# CHANGE NOTICE

**Effective Date:** APRIL 1, 2010  
**Log Number:** CN-1-418  
**Part Description:** DRAIN BALL P/N 00121.30  
**Models Affected:** AH/B/C

## **DRAIN BALL**

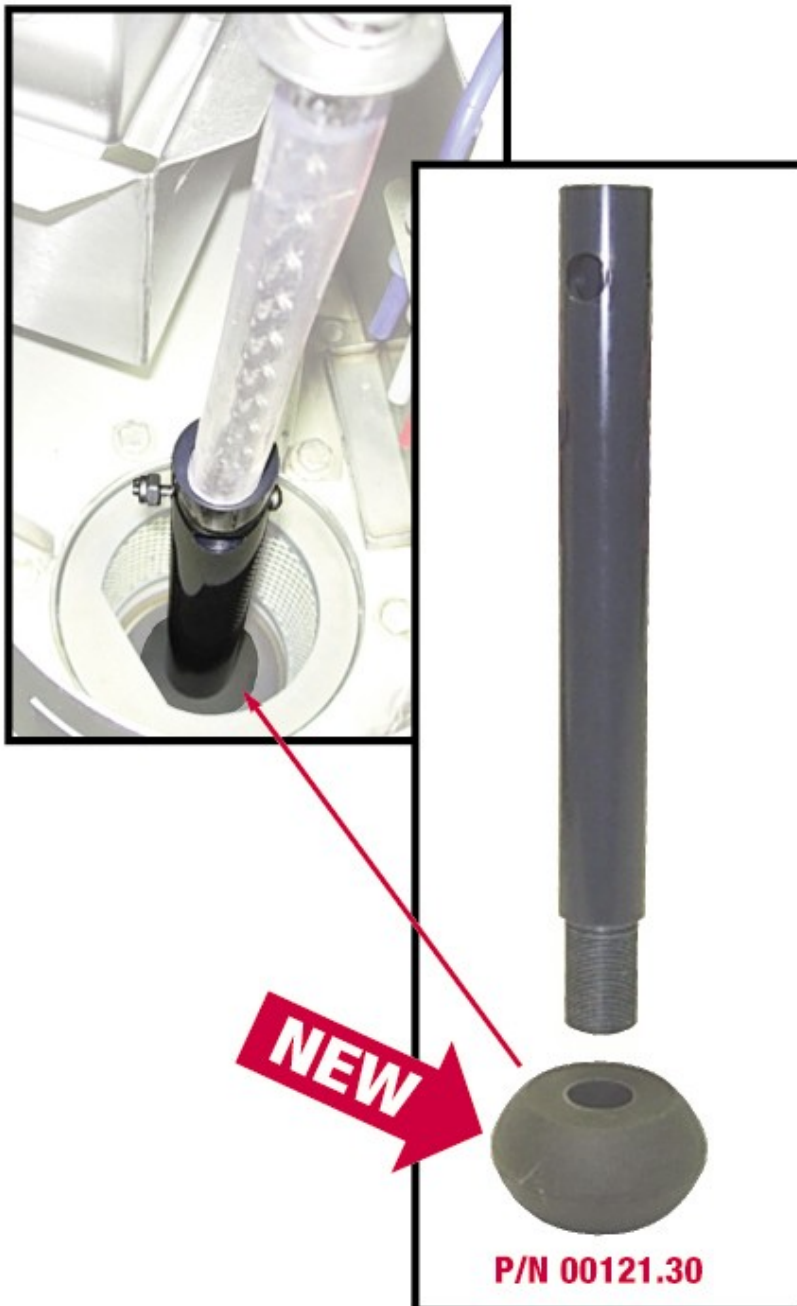
The new "Drain Ball" has been molded from new tooling to conform to the drain tee casting ball seat. It is interchangeable with the older model. The new silicone material is highly chemical resistant and built for longevity and high performance. Through extensive testing we find this new material to have superior quality properties with an ultimate positive sealing.
